SUBJECT: Michigan Department of Environment, Great Lakes, and Energy (EGLE) comments on the Draft Area 6 Phase 1 Field Sampling Plan (FSP) (Draft Phase 1 FSP), dated February 17, 2023, Operable Unit 5 (OU5), Allied Paper Inc./Portage Creek/Kalamazoo River Superfund Site (Site).

**Allied Paper Inc./Portage Creek/Kalamazoo River Superfund Site**

**Phase 1 Field Sampling Plan, Area 6, Operable Unit 5**

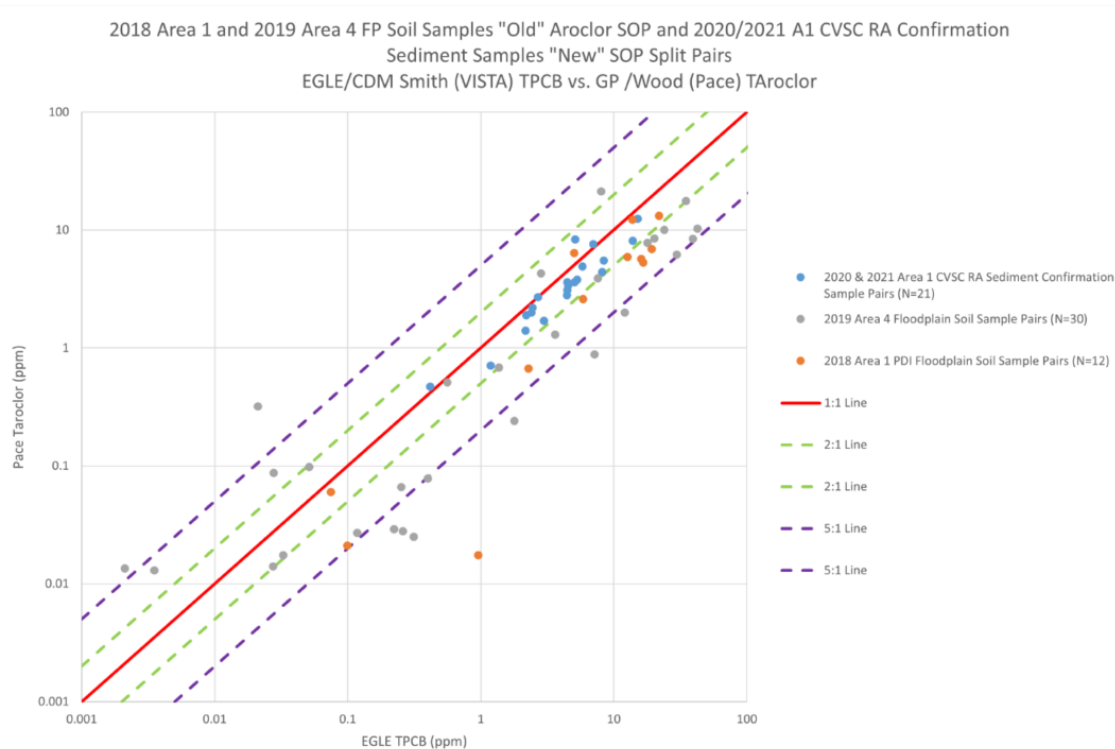
An insignificant problem would not have warranted such a significant effort, and we are grateful for the time that was devoted to this issue. As shown in the 1-1 plot below, the adoption of the site-specific SOP for M8082 has markedly improved the quality of data being generated by GP's lab and it is clear that data collected before and after implementation of the SOP are different. The plot shows that the measured Aroclor result for the parent sample analyzed by GP's lab under the "new" SOP is still generally less than the measured total PCB concentration for the split sample analyzed by EGLE's lab, however; the magnitude of the bias in samples analyzed using the "new" SOP is significantly less than the magnitude of the bias in samples analyzed using the "old" SOP.

Section: Figure 3-14a and 3-14b

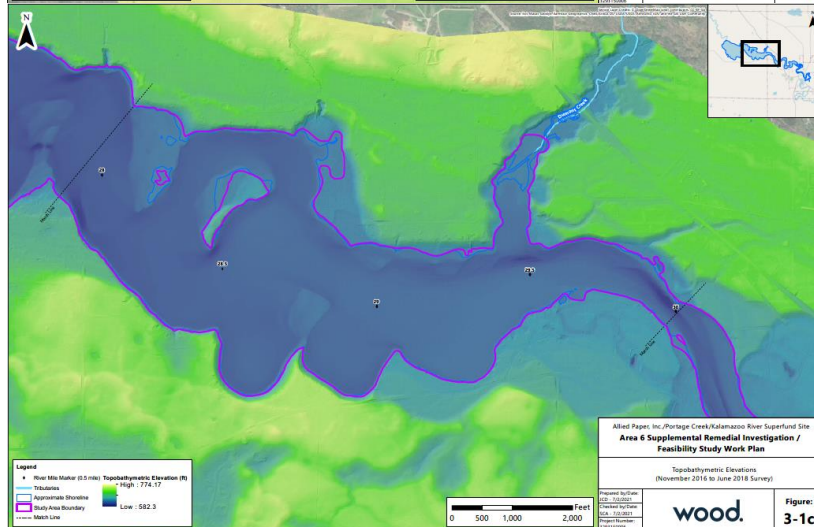
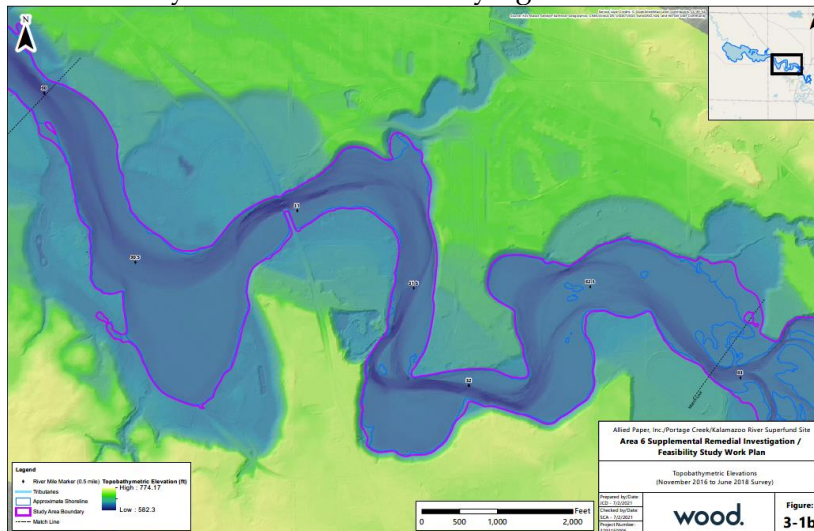
Specific Comment #20: A few comments on these figures:

1. The coarse conformal grid in Figure 3-14b does not extend to the site boundary. Extends the conformal grid up Dumont Creek to the site boundary.
2. Low-lying elevations that should be included in the site boundary appear to have been omitted. For example, there are low-lying areas between river mile (RM) 33 and 32.5, RM 32.5 to RM 30, and RM 30 to RM 28.5 that are not included in the site boundary. Revise the site boundary to include these low-lying areas.

3. The site boundary will need to be refined using data collected during the SRI/FS process. See General Comment #3.
